Letter QA-2614

Subject: Notification of a potential defect per 10CFR21
Exide/GNB NCN batteries

Technical Bulletin
Evaluation of Cracked GNB Battery Posts

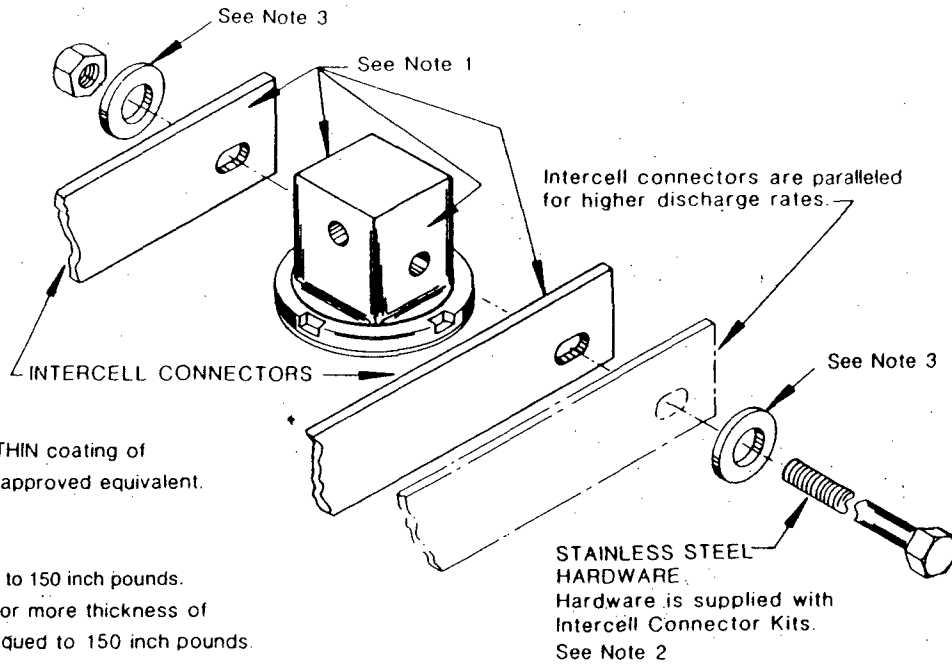
Issue: STP identified cracks in the terminal posts in some GNB NCN-27 cells. The batteries with the cracked posts were manufactured from July 2002 to January 2003. STP has evaluated the operability of the batteries with the cracked posts and determined that the operability and seismic qualification are not impacted.

Figure 2A

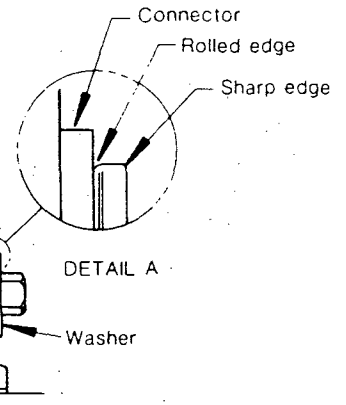
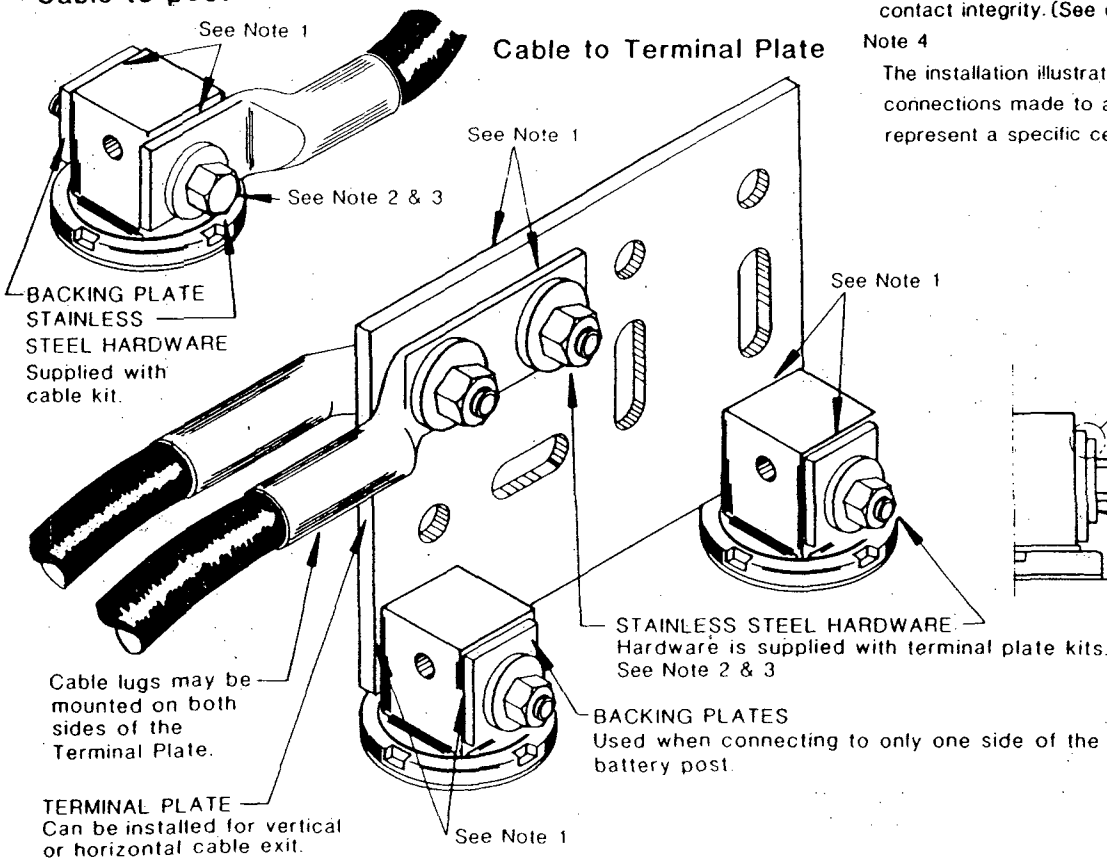
- The cracked terminal posts were identified at the ends of the row of cells, where the terminal plates are bolted to the posts to install the inter-row cables. The GNB instruction manual identifies the required torque at this location as 100 in-lb. The utility had been incorrectly torquing the terminal plate connections to 150 in-lb.

- Note that the required torque for the intercell connectors is 150 in-lb. This torque is not applicable to the terminal plate connections.
 - We have reviewed our manufacturing records for the battery cells with cracks. A contributing factor to the cracking was the busbar casting conditions during the casting of the busbars/posts. The affected timeframe are busbars that were cast from 4/29/2002 to 5/27/2003.

Terminal plate connections are torqued at 100 inch pounds.
